Plan Commission

Agenda

Monday, February 25, 2019	7:00 PM	De Pere City Hall Council Chambers
---------------------------	---------	------------------------------------

6. Recommendation regarding a Site Plan for a building addition for Romo INC at 800 Heritage Road (Parcel ED-F0100-1). Submitted by Skyler Witalison, Mach IV Engineering, authorized representative for Darling Investments LLC, property owner.

C4.0

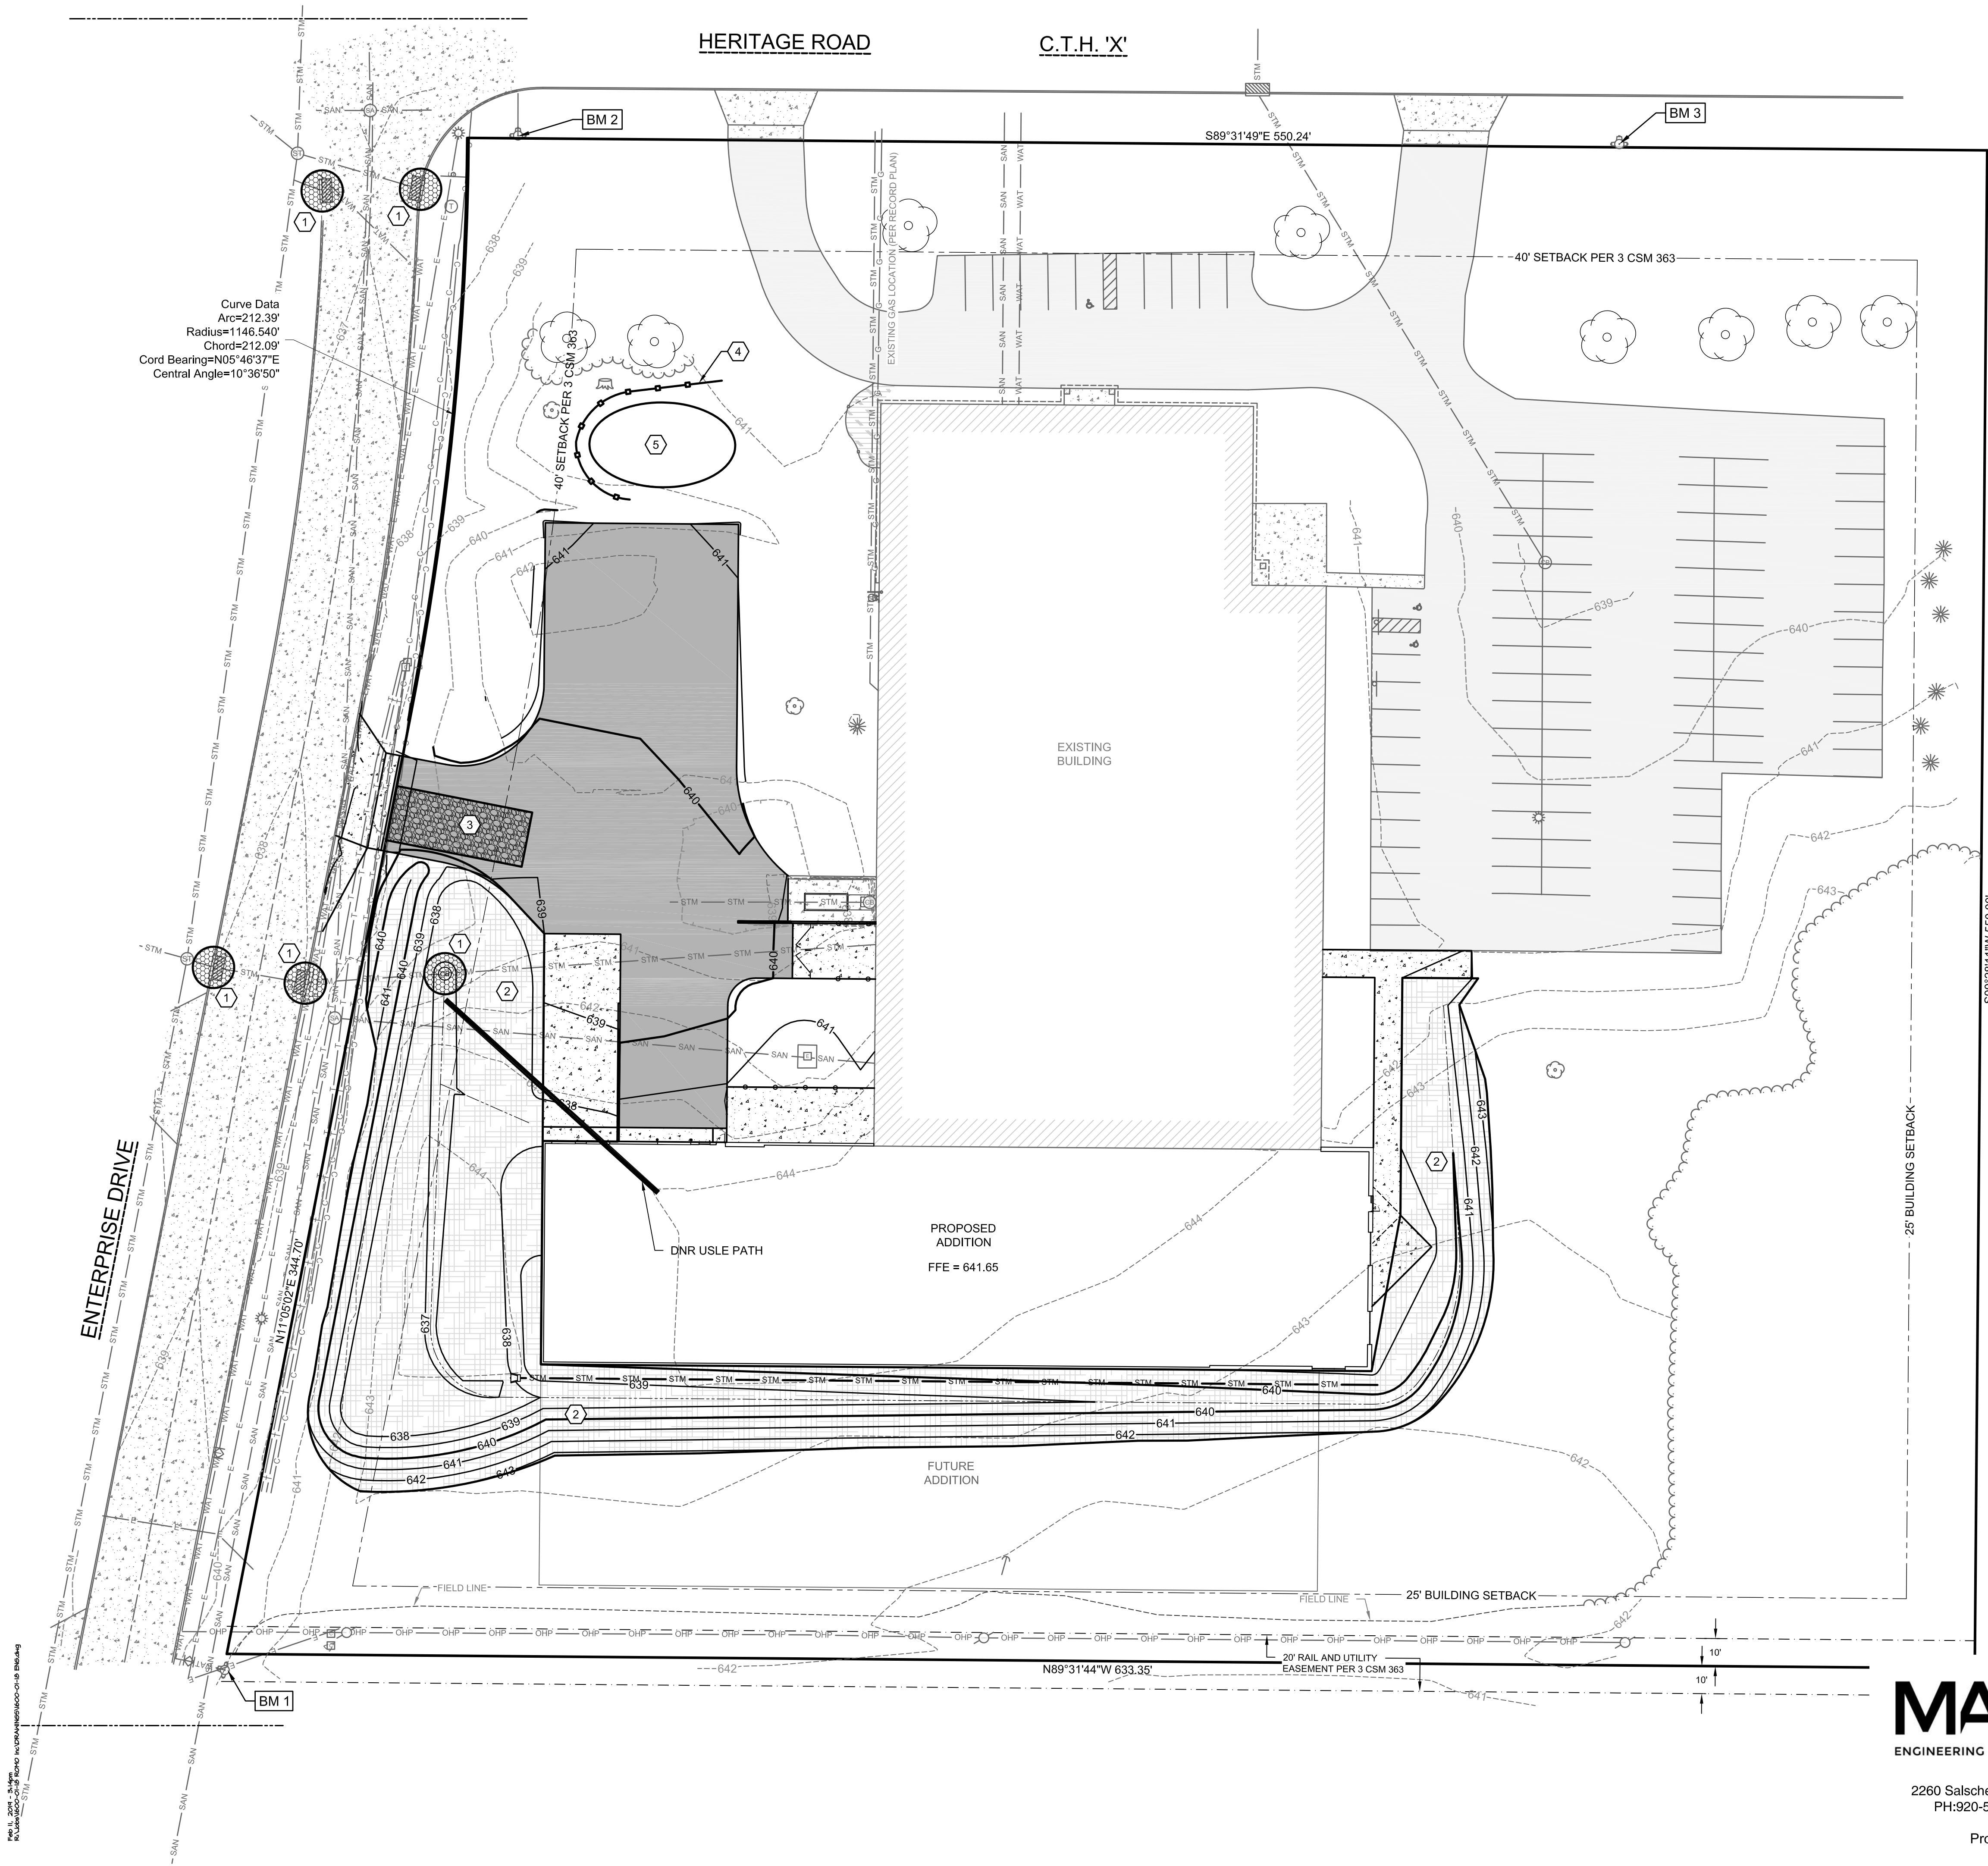
Sheet C5.0 - Key notes are numbered incorrectly on the plan. Numbers two and three are switched on the plan from what is called out in the notes.	CORRECTED

Sheet C5.0 - Need inlet protection at the two inlets on Enterprise Drive at the intersection with Heritage Road. The Road drains to the north and there are areas of site disturbance and vehicle tracking that could impact these inlets.	ADDED C5.0

Sheet C5.0 - Show stockpile locations and required erosion control around them.	ADDED C5.0
